Memorandum Regarding
Evaluation of Model Input
Differences

Discussion of Model Input Differences: EPA's Specific Comment #52 on GE's CMS Report

October 30, 2008

EFDC model grid cells used to define "deep hole".

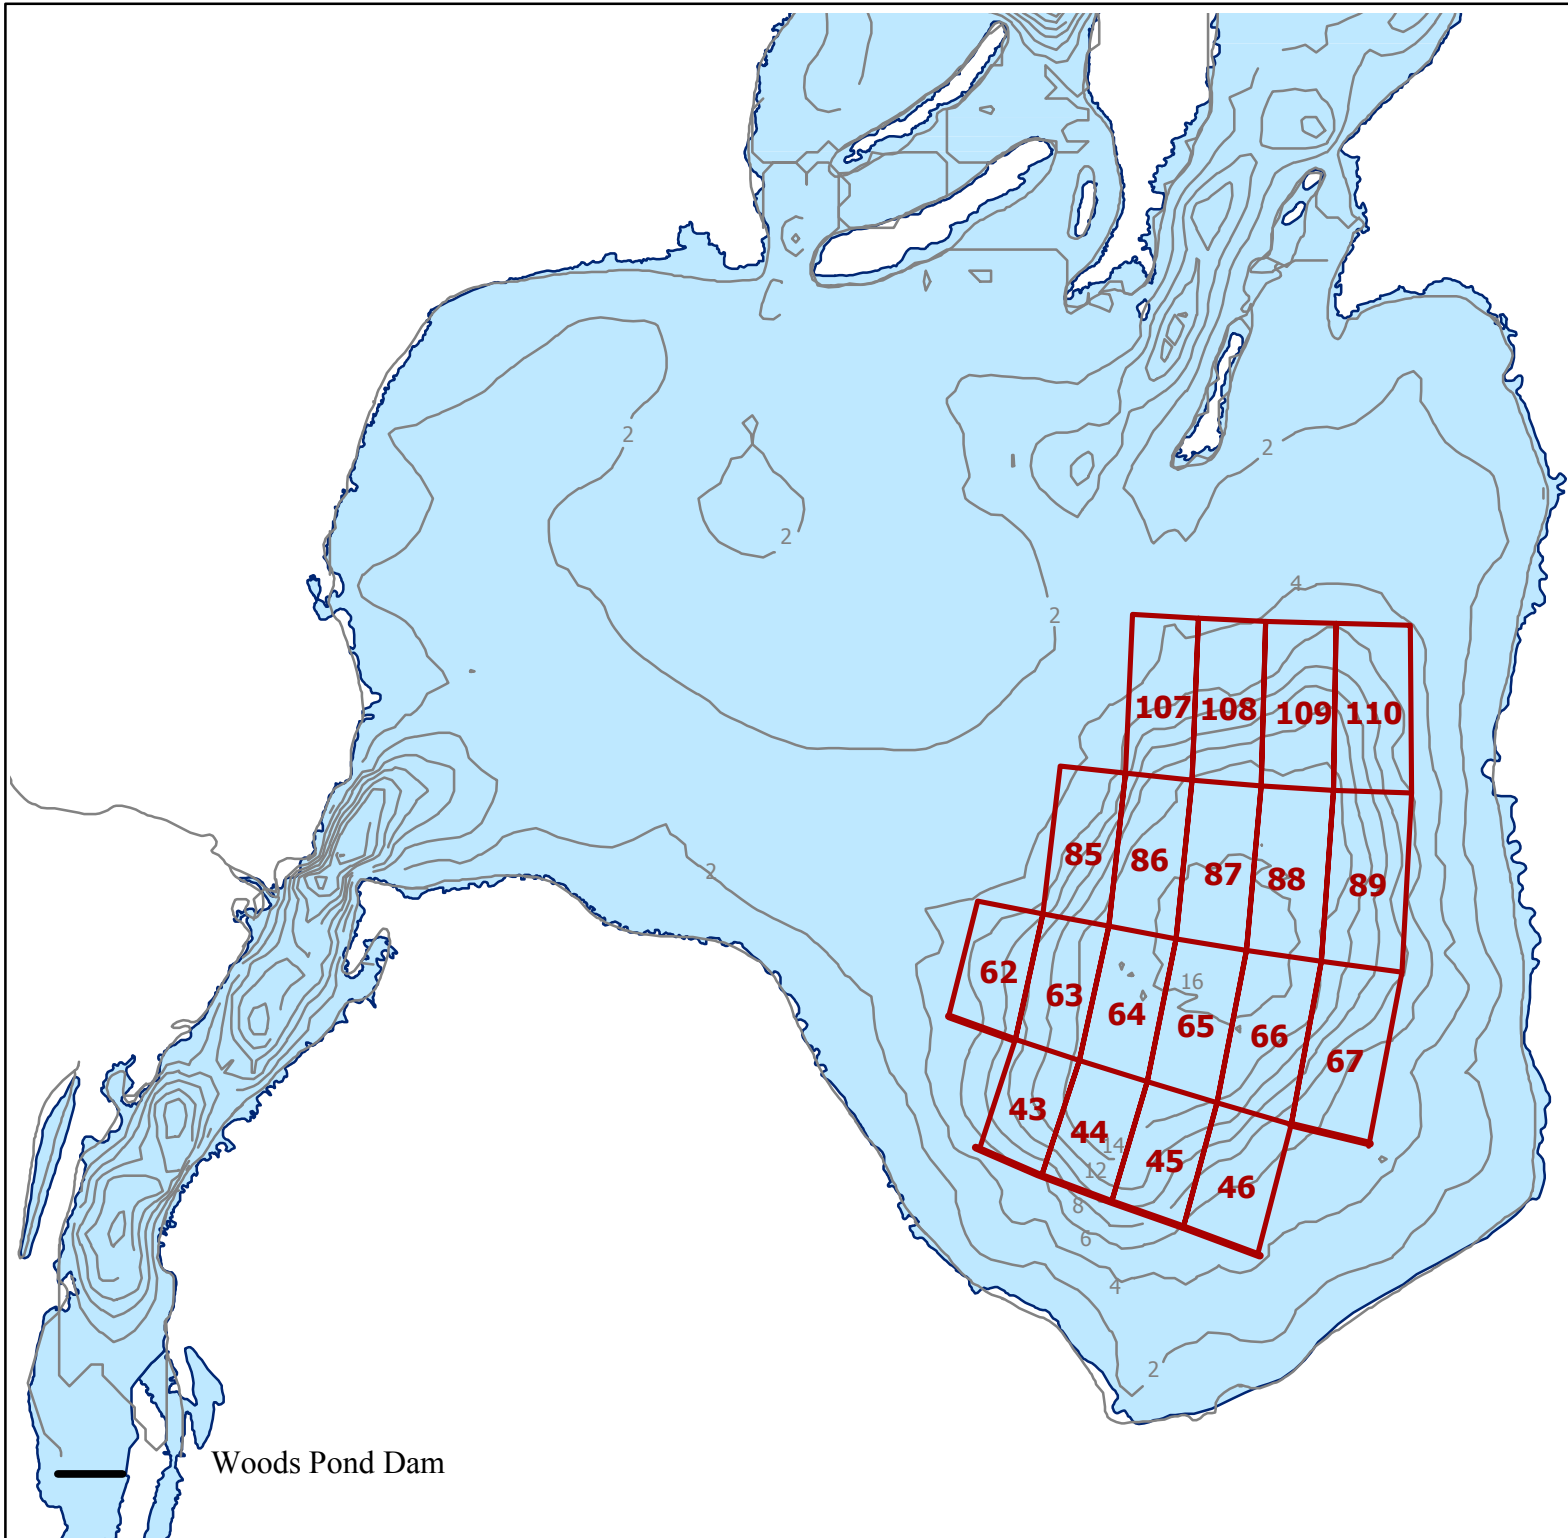
- 3) *The spatial extent of the "deep hole" in Woods Pond used by GE is larger than used by EPA.*

As shown in the attached figure of Woods Pond, GE's selection of grid cells used to represent the "deep hole" was based on the EPA bathymetry contours. This figure demonstrates that the GE-selected grid cells reasonably represent the deep portion of the Pond. It is currently unclear how EPA opted to define the deep hole in the model, and how this definition differs from GE's. Nonetheless, GE expects that differences in the

delineation of the deep hole would likely not have a material effect on model predictions, since all scenarios that include any remedial action (SEDs 3 through 8) specify remediation over the entire Pond. Although several of the CMS alternatives use different remedial technologies in shallow versus deep areas of the Pond, the Pond-wide average surface sediment concentration (immediately following completion of remediation) is not significantly affected by these differences. For example:

Both of these examples illustrate that small differences in the specific model grid cells used to define the deep hole area within Woods Pond would likely not materially impact the model results that were used in comparing the sediment alternatives. To confirm this, EPA would need to provide GE with a list of specific model grid cells it used to define the deep hole in Woods Pond, and the model would need to be re-run for alternatives SED 3 through SED 7.
